CONSTRUCTION DOCUMENTS
MAYBERRY, COLORADO - FILING NO. 4
 BEING A REPLAT OF TRACT A, MAYBERRY, COLORADO SPRINGS FILING NO. 3
 LYING THE NORTHEAST QUARTER OF SECTION 14, TOWNSHIP 14 SOUTH, RANGE 63 WEST OF THE 6TH PRINCIPAL MERIDIAN
 COUNTY OF EL PASO (UNINCORPORATED), STATE OF COLORADO

PCD FILE NO. SF2317

MAYBERRY - FILING NO. 4

CONSTRUCTION DOCUMENTS

**WATER LINE A
PLAN & PROFILE**

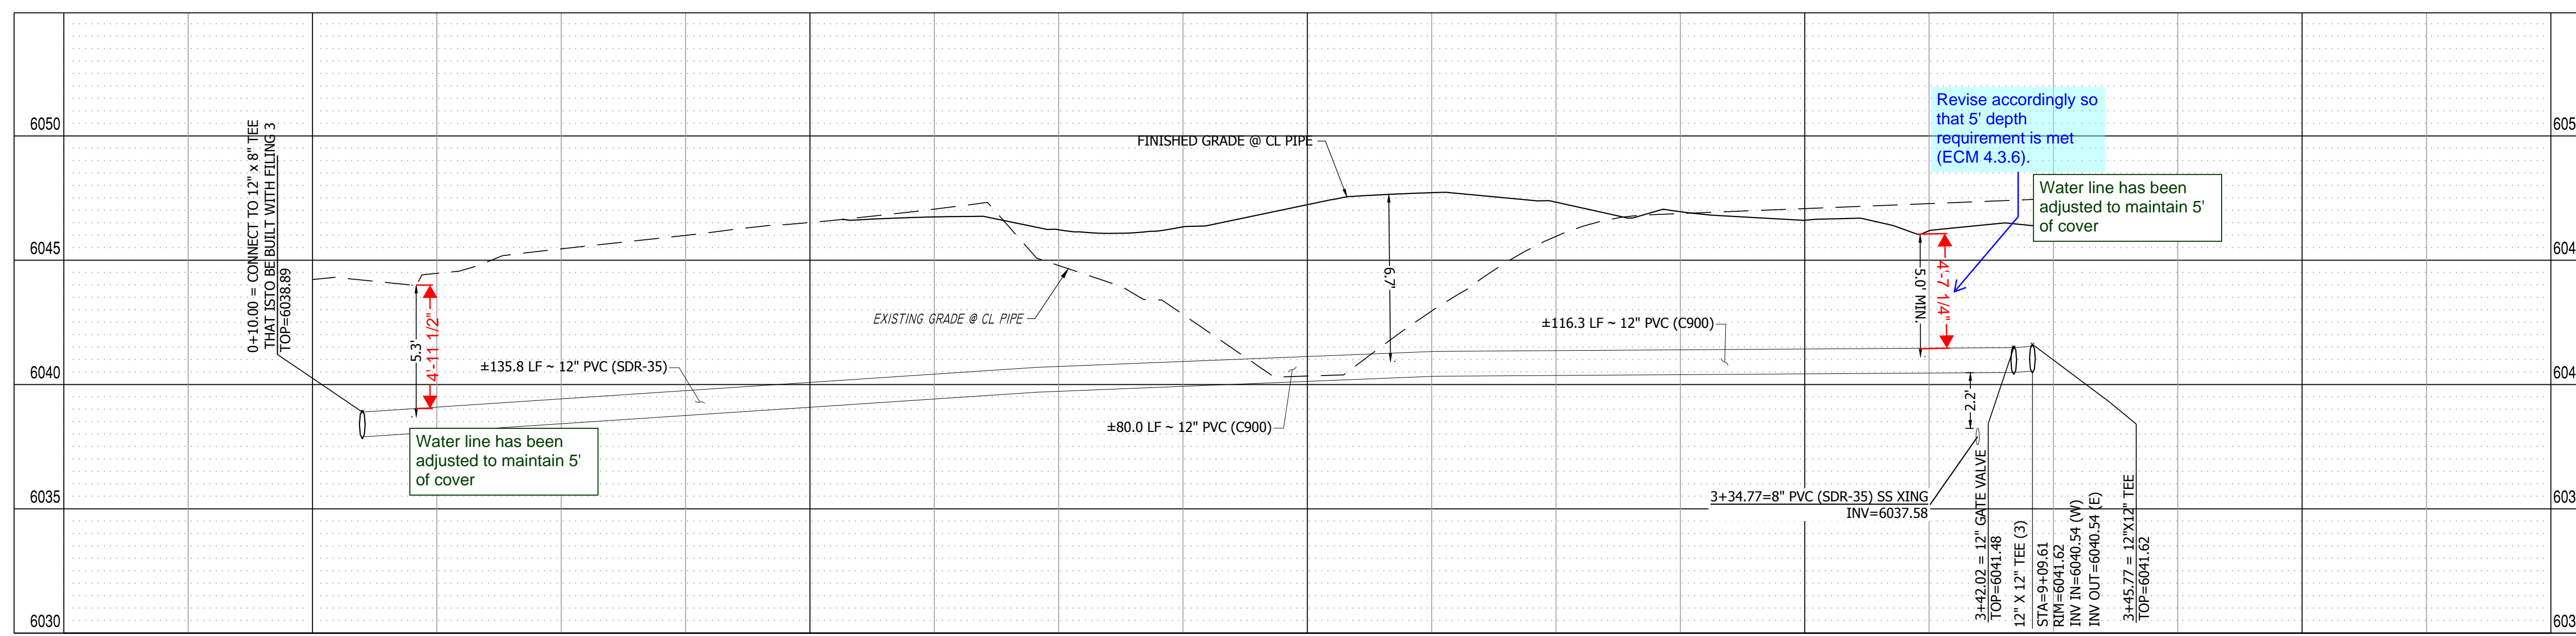
Revise accordingly so that 5' depth requirement is met (ECM 4.3.6).
